Informal document **GRSP-57-26**
(57th GRSP, 18-22 May 2015
Agenda item 10)

**Toxicology and Flammability
Requirements in Child Restraint
Systems Regulations in UN R44 and
UN R129**

ECE/TRANS/WP.29/GRSP/2015/6

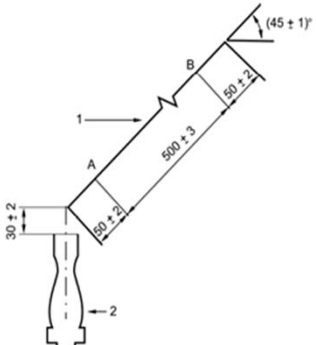
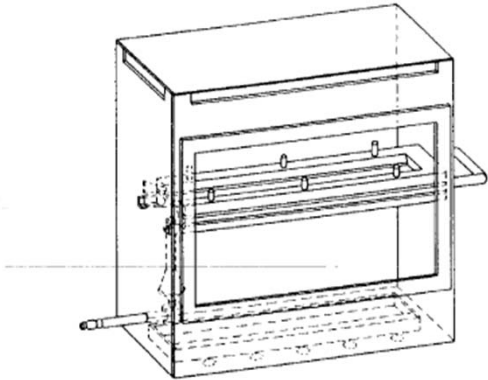
Rate of flame : Moved From 200 mm/min to 100 mm/min in § 6.2.1.

Rate of flame : Moved to 30 mm/s : 1800 mm/min

Sample orientation : Horizontal

Sample orientation : 45°
